# UNITED STATES PATENT AND TRADEMARK OFFICE

| APPLICATION NO.   | FILING DATE | FIRST NAMED INVENTOR | ATTORNEY DOCKET NO. | CONFIRMATION NO. |
|---|-------------|----------------------|---------------------|------------------|
| 10/576,869  | 03/08/2007  | Peter Holzheu        | 41034/44881         | 7881             |

### Office Action Summary

FIG. 2

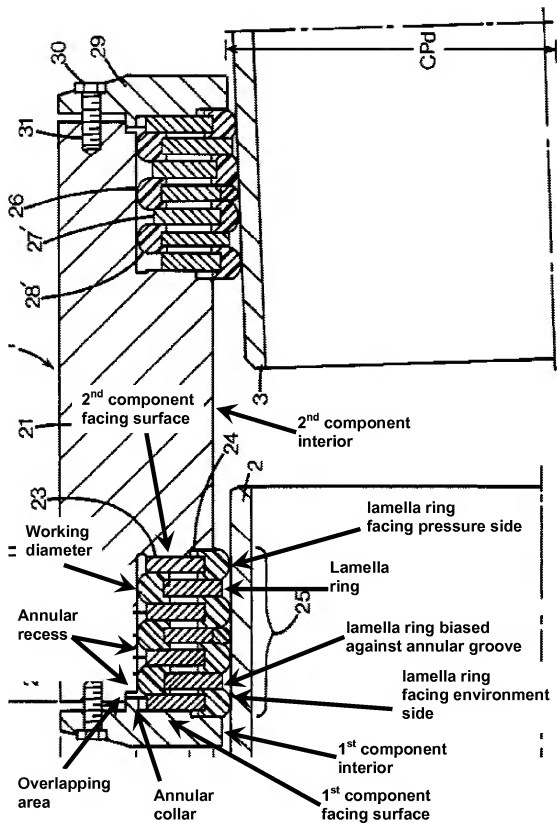
Regarding claim 1, Ekholm et al. discloses a flanged joint (see figure 2a (1)) for a pressurized medium (column 2, lines 27-29, which disclose providing a seal against different pressures), the flanged joint comprising: a first component (21) and a second component (29) having an interior (see figure 2 below);

at least one flat gasket (see figure 2b (26a)) held between facing surfaces (see figure 2 below) of the first and second components;

an annular groove (see figure 2a (22)) and a radially opposed working diameter (see figure 2 below) located between the interior and the at least one flat gasket (see figure 2 below); and

at least one lamella ring (see figure 2 below) held in the annular groove and biased, essentially without a gap, against the working diameter (see figure 2 below).

Regarding claim 5, Ekholm further discloses the plurality of lamella rings includes at least one lamella ring facing the pressure side (see figure 2 below) and at least one lamella ring facing the environment side (see figure 2 below) and those rings being biased against the working diameter (see figure 2 below), and the plurality of lamella rings includes at least one lamella ring is biased against a bottom of the annular groove and axially arranged between the at least one lamella ring facing the pressure side and the at least one ring facing the environment side (see figure 2 below).

Regarding claim 10, Ekholm further discloses the first and second components include a radial overlapping area (see figure 2 below) such that one of the components includes an axially protruding annular collar (see figure 2 below) engaging a complementary, annular recess (see figure 2 below) of the other component, the other component having an inner circumferential surface forming the working diameter (see figure 2 below).
